## **RE:** Comments on the Draft Environmental Impact Report for the Lehigh Permanente Quarry Reclamation Plan

### Re: Comments on the Draft Environmental Impact Report for the Lehigh Permanente Quarry Reclamation Plan Amendment

Figure 1. Average Mercury Concentration of Limestone

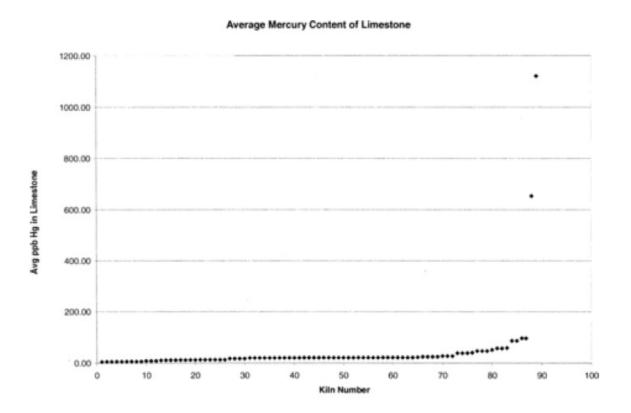
Scenarios, what assumptions are being made about the speciation and fraction of particle-bound mercury in overall mercury emissions from the kiln?
